# Statement of Environmental Effects

Application under Section 96(1A) to Modify  
Development Consent SSD 5093  
North Ryde Station Precinct M2 Site -  
Lachlan's Line

Prepared for UrbanGrowth

19 May 2016

**Figure 2 Bridge Landing Pad and amended subdivision layout – Lot 103 and 113**

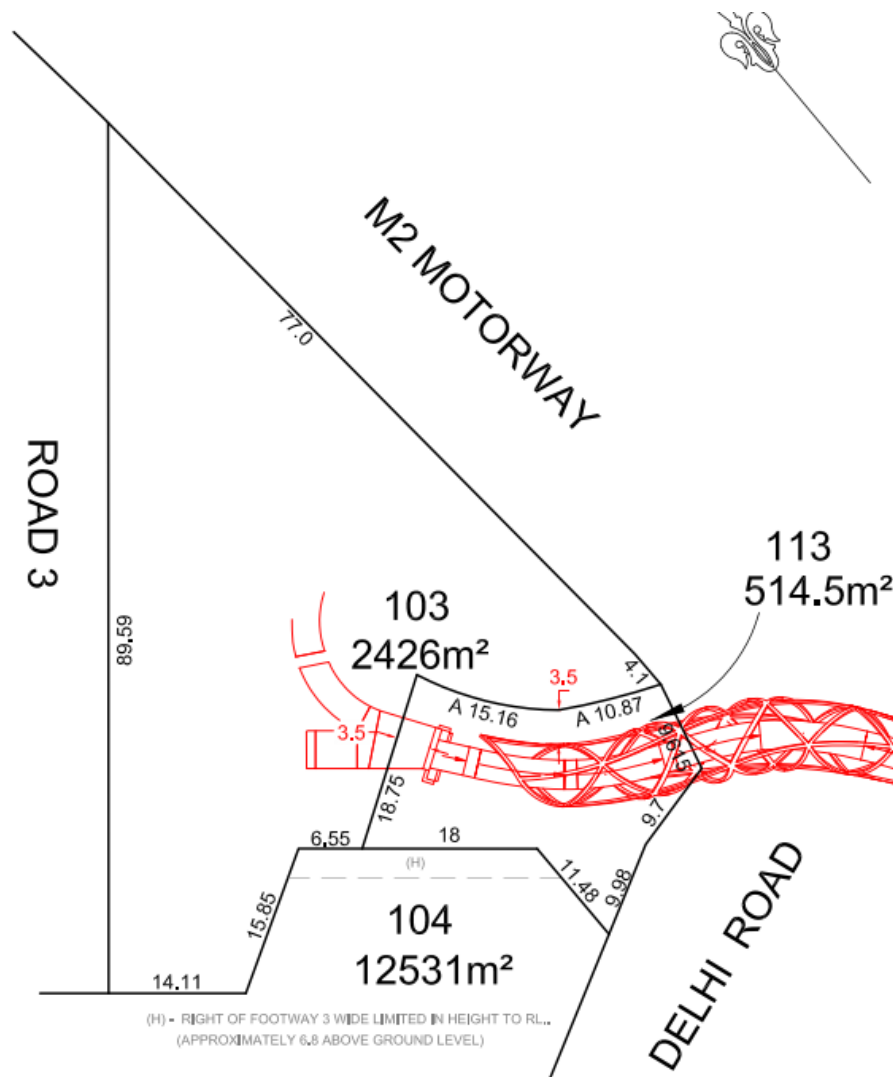
The land on which the pedestrian and cycleway bridge is located will be dedicated to the Roads and Maritime Services (**RMS**) when complete. As such, it is appropriate to further subdivide Lot 103 to exclude that land which will be dedicated to RMS for the bridge abutment on this part of the site from the land to be dedicated to Council as park. This arrangement is consistent with the draft Planning Agreement being negotiated between UrbanGrowth NSW and Ryde City Council.

**Figure 2** below show the location of the bridge landing pad in relation to the new lot boundary. The figure illustrates the further subdivision of Lot 103, reducing the lot area from 2,941m<sup>2</sup> to 2,506m<sup>2</sup> to create Lot 113 consisting of 435m<sup>2</sup>. A copy of the revised subdivision plans is provided at **Appendix B**.

Amend the table referenced in Condition A5 to add the following plans:

<i>Draft Subdivision Plans by Scott Deveridge</i>			
<b><i>B1505-B1612 - OVERALL</i></b>	<b><i>K</i></b>	<b><i>Overall plan of subdivision Plans 1-4</i></b>	<b><i>18.6.15</i></b>
<b><i>B1505-B1612-PLAN3-K</i></b>	<b><i>K</i></b>	<b><i>Plan of Subdivision of Lot 10 in DP (Plan 2)</i></b>	<b><i>18.6.16</i></b>
<b><i>B1505-B1612-PLAN4-C</i></b>	<b><i>C</i></b>	<b><i>Plan of subdivision of Lots 102 and 110 in DP (Plan 3)</i></b>	<b><i>18.6.16</i></b>

TITLE: EARTHWORKS LAYOUT PLAN - OPTION 1

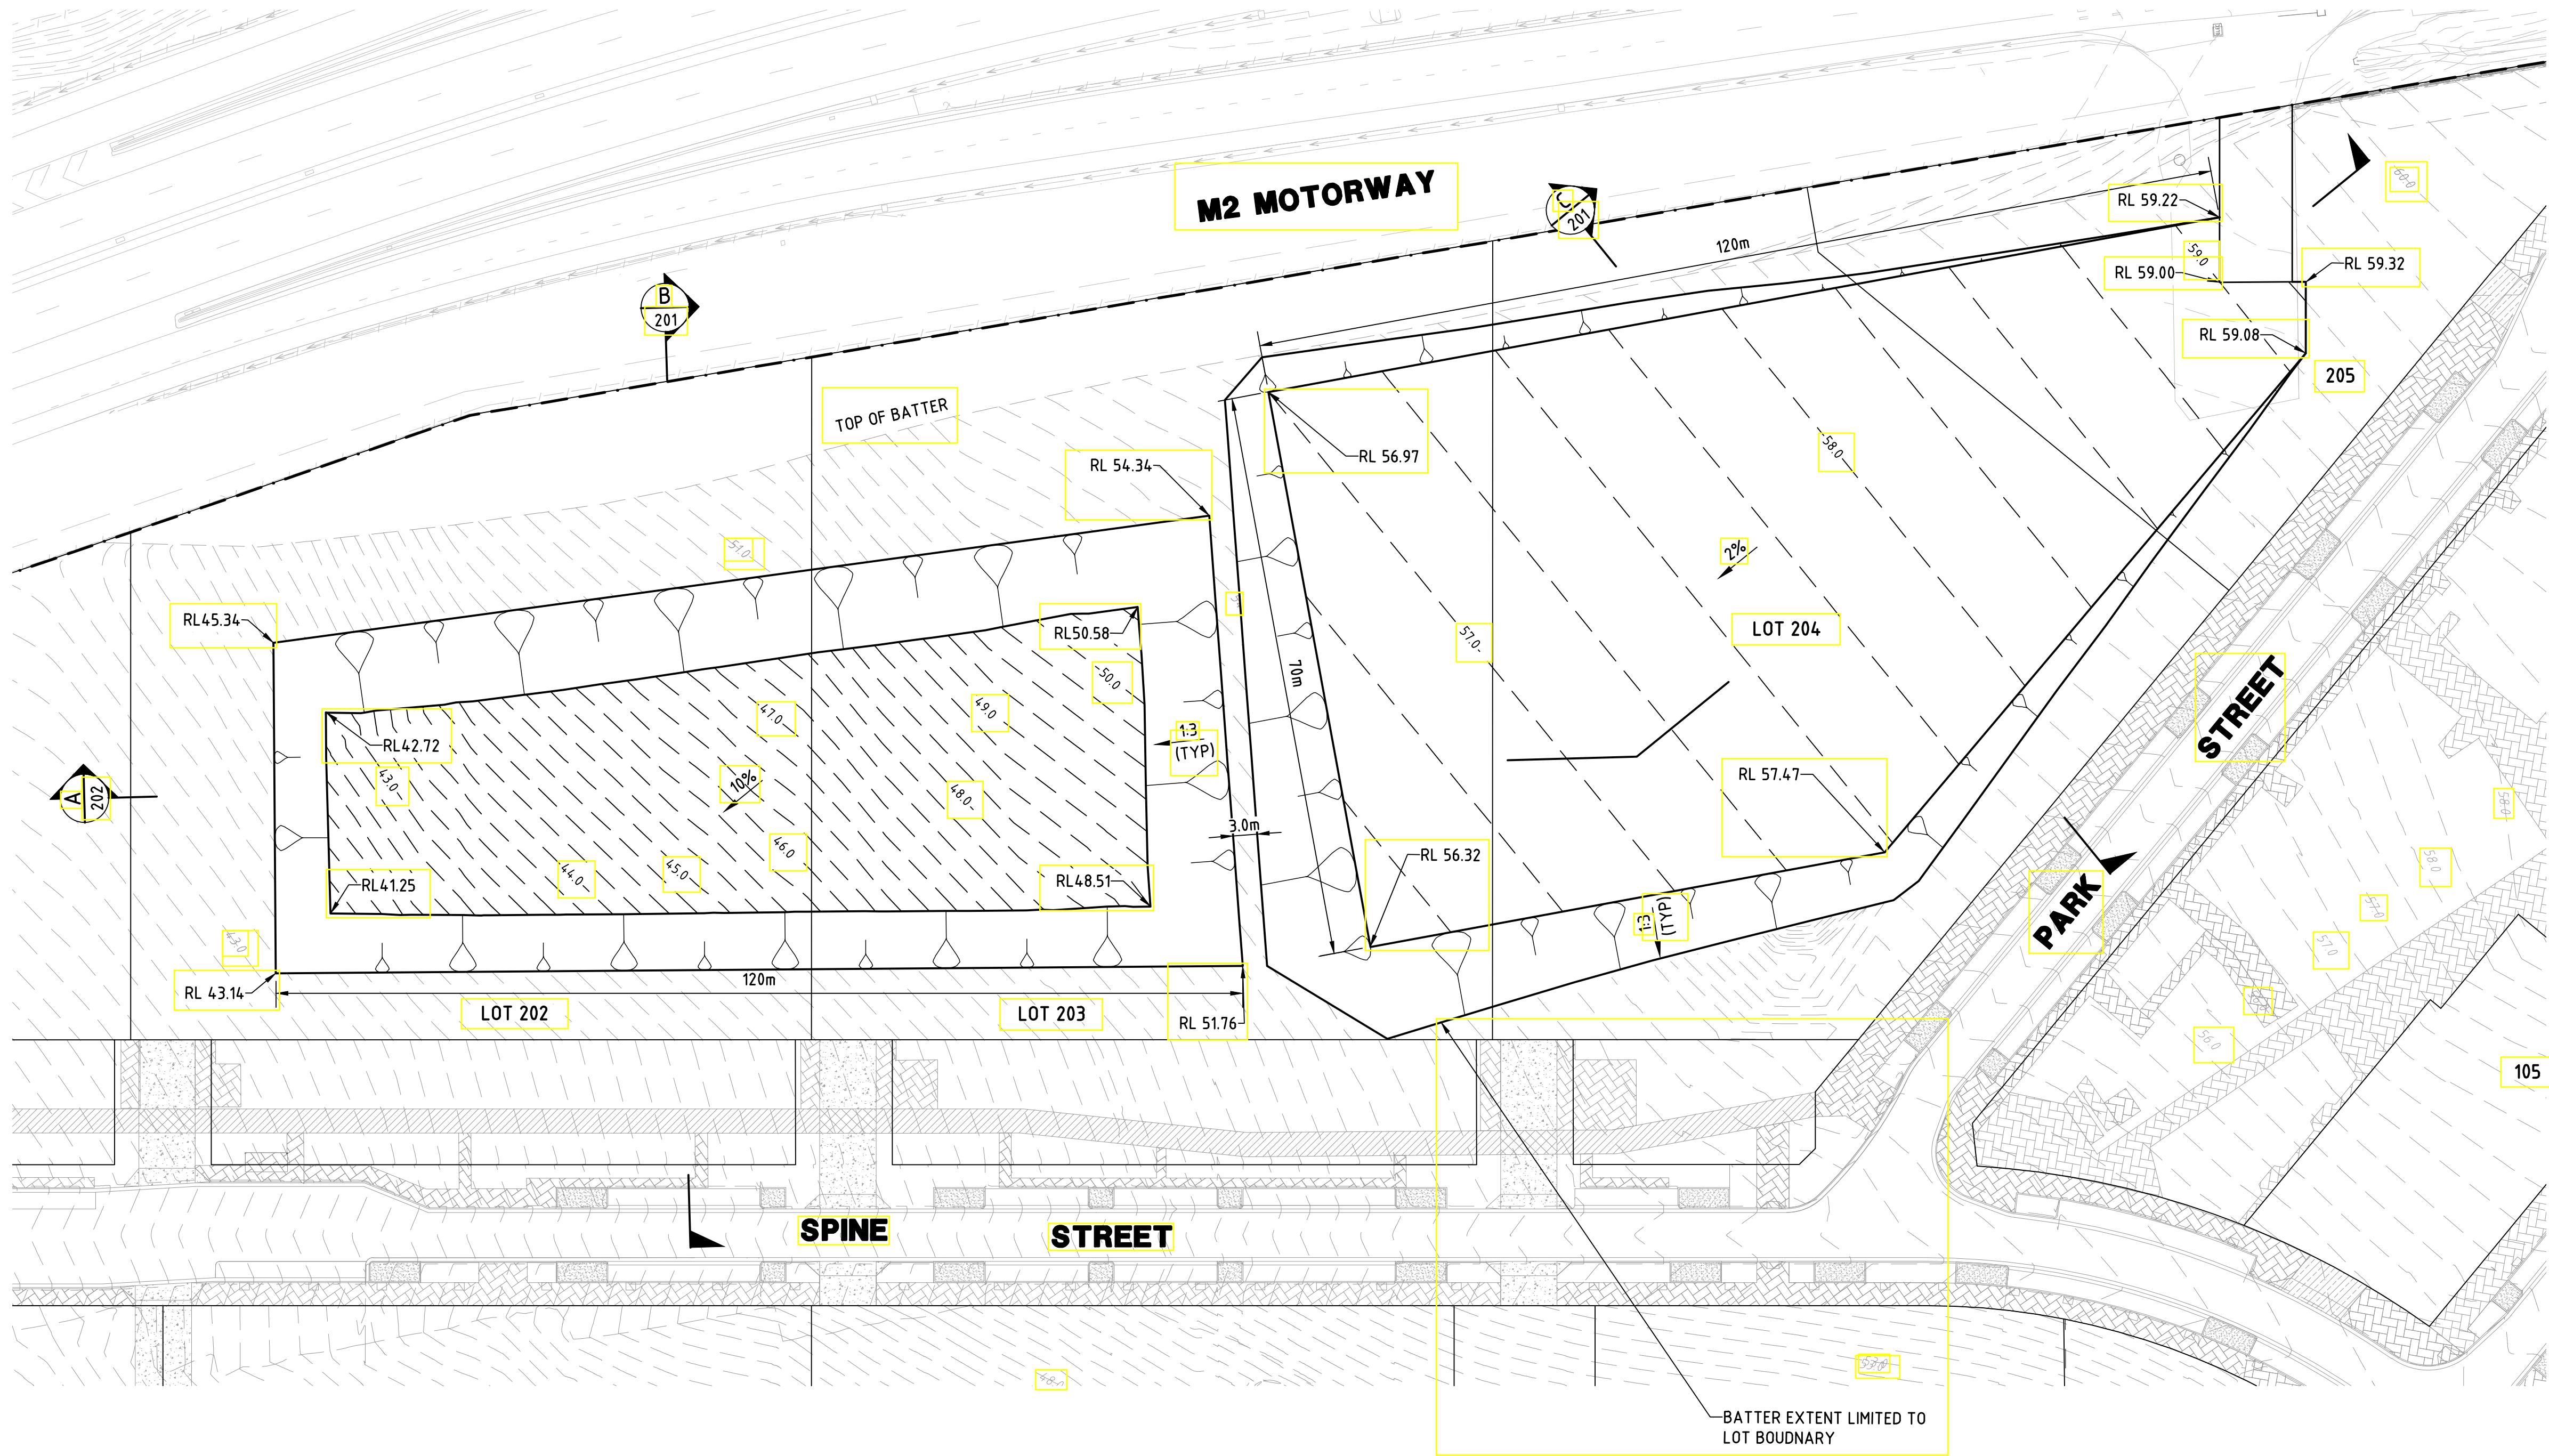
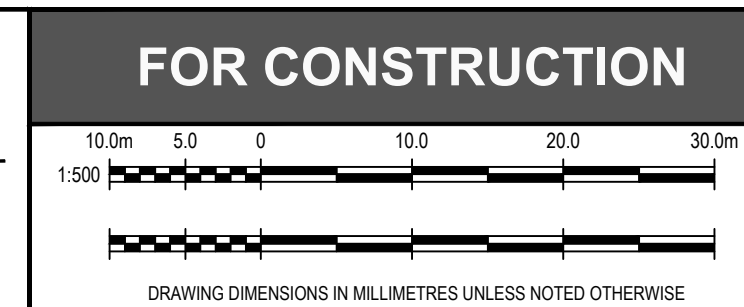
It is proposed to create a level platform on site for the construction and assembly of the bridge spans. To do this, it is proposed that the approved bulk earthworks be amended to create a borrow pit to generate the fill required for the platform. The

borrow pit will be retained for sediment erosion control purposes and refilled at the end of works to achieve the approved levels or alternatively, incorporated into the works for future basements of apartment buildings on this part of the land.

UrbanGrowth NSW will be responsible for the ongoing maintenance and will erect ATF fencing around the pit. Plans of the borrow pit and bridge assembly PAD are attached at **Appendix A**.

<i>Bridge Assembly Area Plan by Diversi</i>		
<b>SKC30 Rev 1</b>	<b><i>Earthworks Layout Plan Prepared by Diversi</i></b>	<b>6/5/16</b>

***The bulk earthworks will include the excavation of a borrow pit to prepare a level platform (PAD) on site for assembly of the pedestrian bridge, as shown in Plans prepared by Diversi dated 6 May 2016. The bridge assembly area will be fenced and maintained (including de-watering of the borrow pit). At the completion of the bridge assembly, the borrow pit will be either:***

- a) reinstated to approved levels; or***
- b) retained to be incorporated in future constructions works for mews roads and basements within these lots.***

***If the borrow pit is not to be incorporated into future construction on the development lots, it will be reinstated to the approved levels by December 2018.***
